**Request for Proposal  
SSES Phase 5 Project Addendum # 2 to  
RFP No. 179821.78.0052  
December 8, 2016**

**Updates to Request for Proposal (00180.3 Scope of Work and Map)**

**Phase 5 Contract Areas**  
 City of Memphis, TN WWTCS Study  
 179821

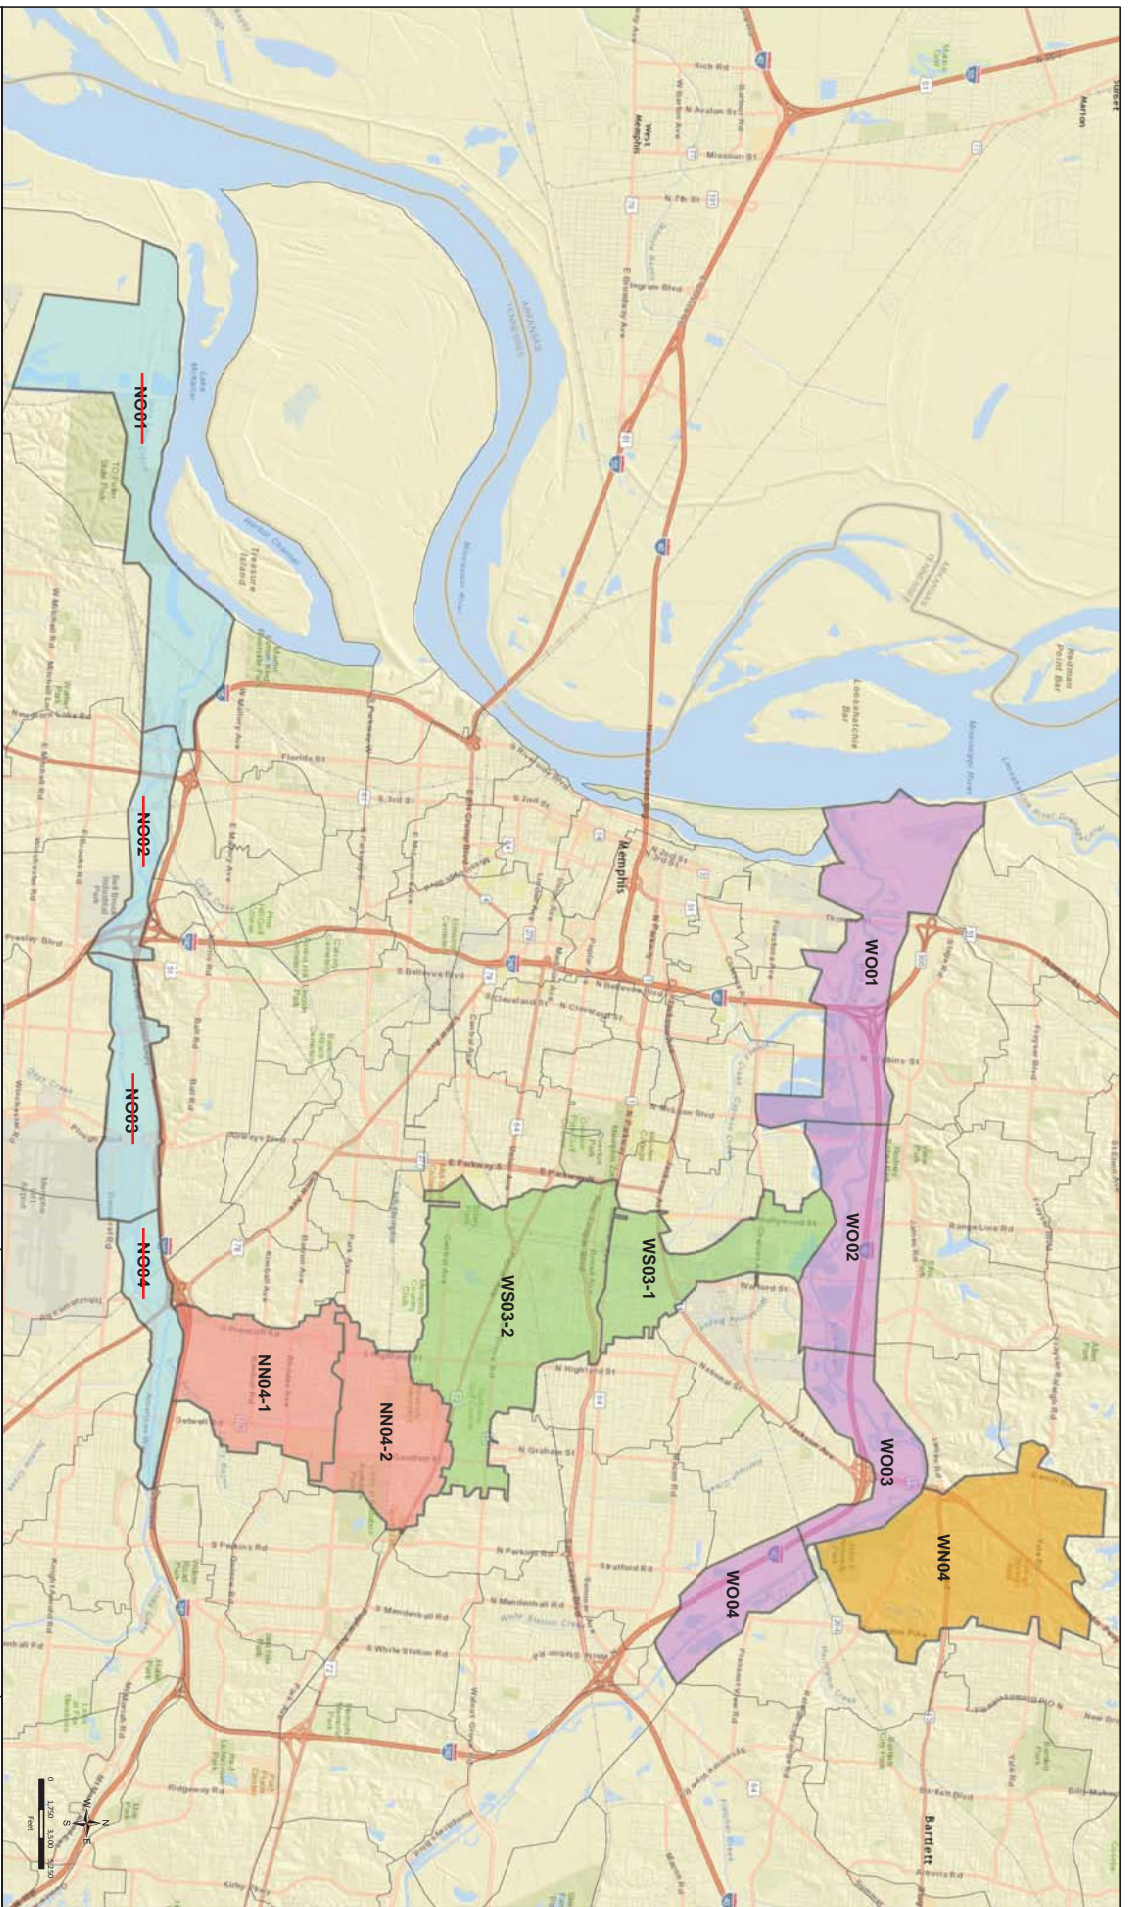
#### ~~**SERVICE CONTRACT 78.0056 – Nonconnah Interceptor (NO01, NO02, NO03, NO04)**~~

~~*Task: CONDITION ASSESSMENT OF SANITARY SEWER LINES AND MANHOLES*~~

~~Service Contractor 78.0056 shall be responsible for completion and correct documentation per Technical Specifications of a condition assessment of the interceptor sanitary sewer lines (54" and greater) and associated manholes in the assigned Phase 4 Phase 5 Area. This work would consist primarily of large diameter sewer interceptor assessment and necessary cleaning along the Nonconnah Creek. The Nonconnah Interceptor (NO01, NO02, NO03, NO04) would be assigned to Service Contractor 78.0056.~~
